**Federal Aviation
Administration**

Updated Response to
Oakland Airport-Community
Noise Management Forum's Recommendations

August, 2018

Figure 1 - Comparison of SILENT (orange) and HUSSH (green) ground tracks.
NOTE – Tracks not assigned these SIDs have been removed for clarity.

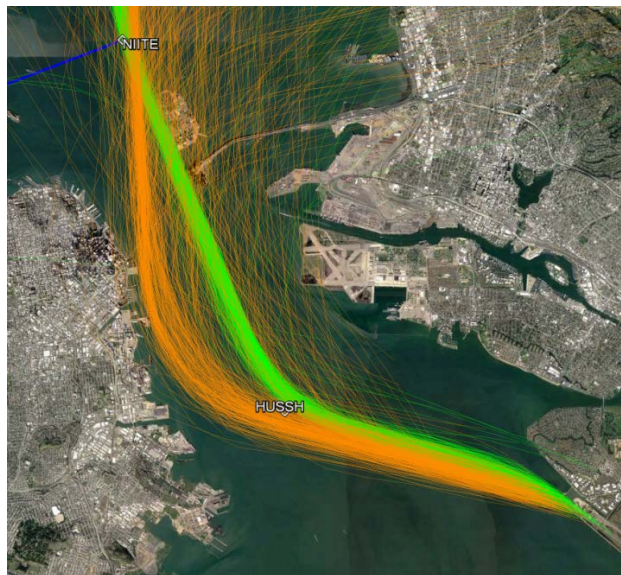
- 1.1 **"The short-term solution would be for Air Traffic Control to assign headings to aircraft departing OAK runway 30 that restore the initial SILENT ground track."**

Explanation: The FAA cannot support this recommendation for the following reasons. The SILENT Standard Instrument Departure (SID) is a conventional procedure that uses ground-based navigation. While the SILENT SID is still a published procedure, it has largely been replaced by the HUSSH SID, which is an RNAV procedure that uses satellite-based navigation and provides much greater precision. The OAK Noise Forum's recommendation to restore the conventional SILENT SID ground track may provide minor relief from noise concerns on the east side of the Bay, but a return to the SILENT SID ground track will create significant noise concerns for the San Francisco area. As illustrated in Figure 1 below, the HUSSH SID (green) is generally in the middle of the Bay until the REBAS waypoint (not pictured). The SILENT SID (orange), however, averages within 0.5 NM of downtown San Francisco.

Figure 3 – For clarity, only the TIPRE / SYRAH transitions to TAMMM are shown, as well as tracks for those transitions.

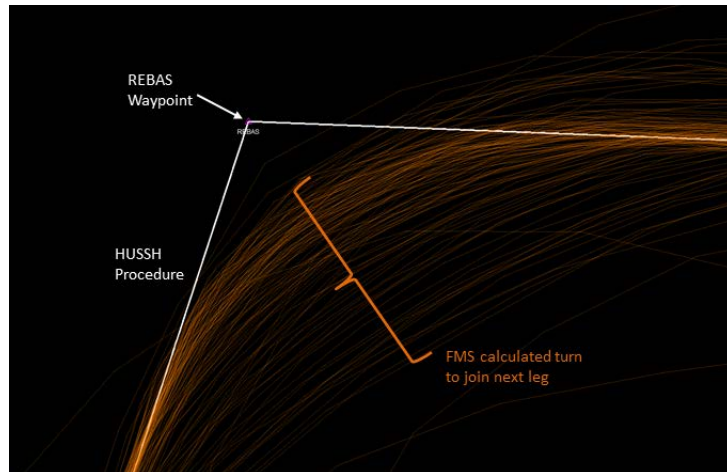
1.3 “...evaluate the HUSSH procedure and adjust it to replicate the SILENT SID ground track and require aircraft to fly to REBAS unless safety dictates otherwise and adjust the REBAS intersection offshore to keep aircraft over the water instead of turns over land.”

The FAA cannot support this recommendation for the following reasons. Moving the REBAS waypoint west of its current location would jeopardize safety because it removes the requisite separation. As illustrated in Figure 3 (below), the REBAS waypoint is a fly-by waypoint, meaning aircraft are not required to overfly the waypoint. Rather, the aircraft’s Flight Management Software (FMS) will calculate when to start its turn prior to REBAS (based upon weather, aircraft performance, weight, etc.) so the aircraft smoothly joins the next leg of its route.

Figure 6 - HUSSH procedure (White) and HUSSH departure tracks (Orange), illustrating FMS calculated turn.

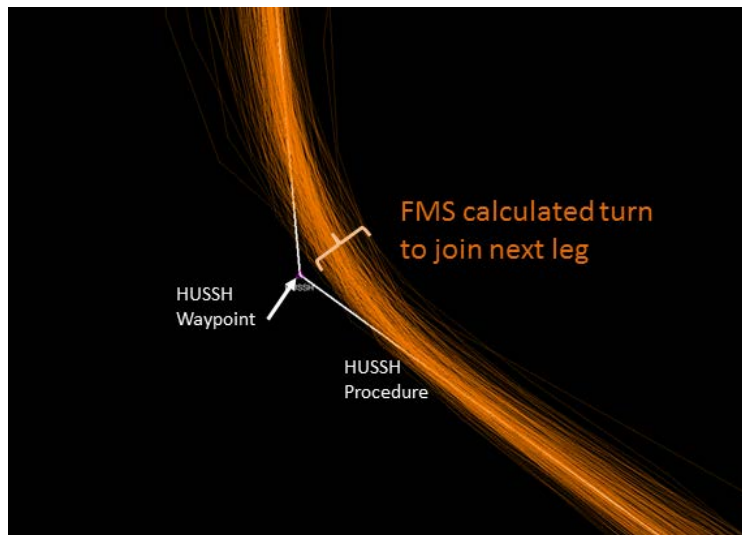
1.4 “...moving HUSSH waypoint southward as much as feasible to facilitate a sharper left turn by aircraft after departing OAK runway 30”

within aircraft/airline flight profile limits. Generally speaking, the more acute the angle is between two route segments, the greater the divergence will be from the waypoint. This is illustrated in Figure 6; the segment angle at HUSSH is 130°.

This characteristic of RNAV SID procedures would preclude any benefit to the modification of the HUSSH waypoint. By moving the waypoint to the south, the turn required to join the next segment to NIITE would not have a noticeable impact to the flight tracks over the ground.

Figure 7 - Current WNSDR STAR (Magenta), Proposed Procedure (Blue)

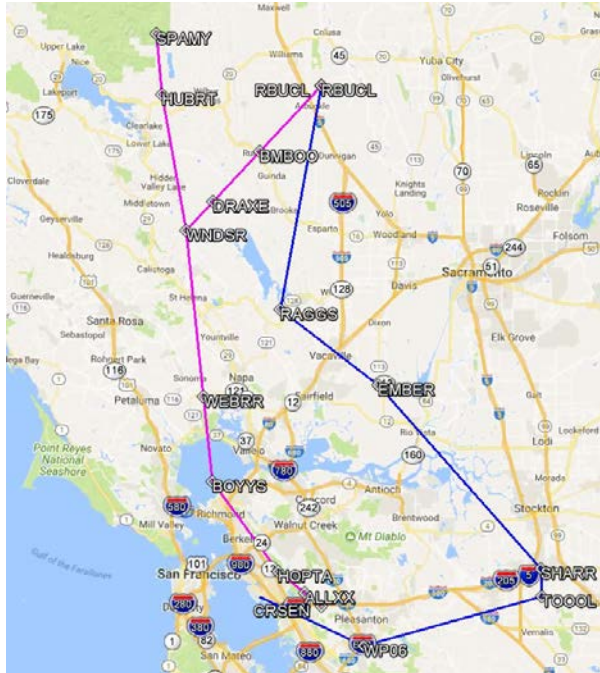
- 2.2 **North: “...the FAA consider establishing the preferred alternative of OAK to the east. This alternative proposes the FAA consider an RNAV somewhere within a corridor... .. generally encompassing the Mendocino VOR to the Santa Rosa VOR to RAGGS fix then airway V494 towards EMBER and then towards SHARR fix and joining the MADWIN SIX arrival for flights arriving from the north. “**

1. This recommendation would shift aircraft noise from one community to another (see Figure 7 below). The FAA cannot support creating a procedure without consensus from all affected communities. For example, this proposed route would originate just to the south of Lake Berryessa (near the RAGGS waypoint), then proceed in the vicinity of Vacaville and Manteca before turning west towards the OAK airport, shifting the main segments of the WNDSR to the east.

Figure 9 – CNDEL SID (tracks in green, procedure in yellow) and SSTIK SID (tracks in magenta, procedure in blue).

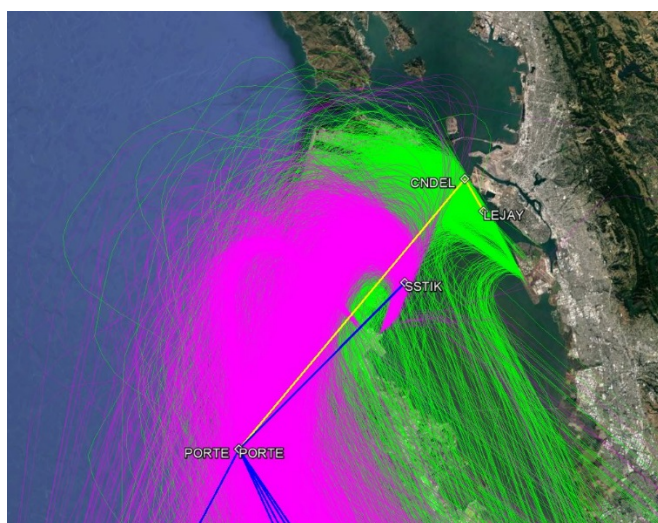
- 4.1 **“Consider adjusting CNDEL THREE departure so that the ground track for this departure is further away from BFI/Alameda. This could be accomplished by directing aircraft departing OAK runway 30 to turn left to a heading of 280° until reaching the OAK 4 DME arc.”**

Explanation: The FAA cannot support this recommendation for the following reasons. The geographical relationship between SFO and OAK flight operations precludes the amendment of one procedure without affecting another. One example of this, as illustrated in Figure 9 (below) is the SSTIK SID from SFO and its impact on OAK departures. Similar to the HUSSH and SILENT SIDs, an assignment of a 280° heading for CNDEL departure aircraft does not ensure the required separation will be maintained with aircraft on the SSTIK SID.

Similar to the issues caused by the recommended changes to the HUSSH SID (please refer to OAK Noise Forum Recommendation 1.1 for more information), an initial heading of 280° for OAK departures would provide minimal benefit to the area of BFI/Alameda. As stated previously, the increase in delays caused by a mandatory heading such as this would be severe; a 280° heading would remove lateral separation provided by the procedures and in order to ensure safety would require the individual coordination of CNDEL departures from OAK, which would impose major delays for both SFO and OAK airports.

Figure 10 - SFO TRUKN Departures from runway 01.
Average altitude at TRUKN waypoint (indicated by black arrow) – 5,176' MSL.

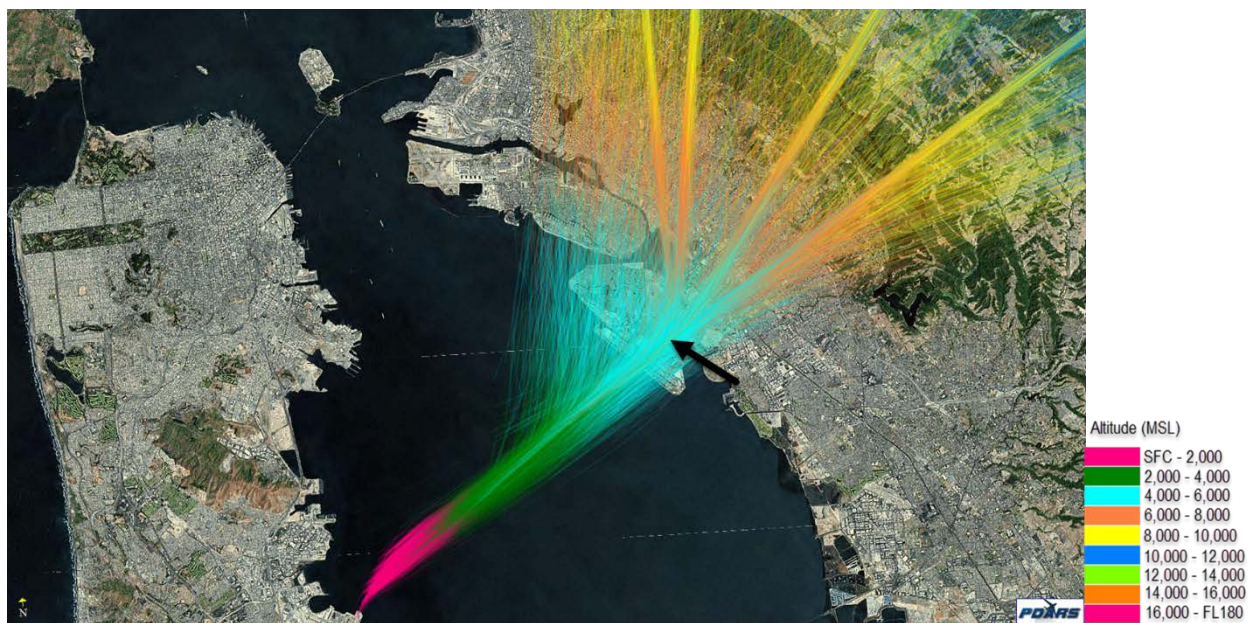
- 6.5 “... the FAA investigate for both TRUKN North and TRUKN East: Analyze if a procedural decrease in altitude over TRUKN exists and whether higher altitudes can be restored.”**

Another consideration is altitude restriction. If altitude restrictions were added to the TRUKN departure procedure to increase the climb gradient (increase in altitude over a set distance over the ground), the highest crossing restriction that could be applied at TRUKN waypoint would be at or above 4,530 ft. MSL. Based on preliminary feasibility focusing on flight procedures criteria and overall fly-ability, the average altitude of flight tracks (from runway 01 at SFO) was 5,176 ft. MSL.
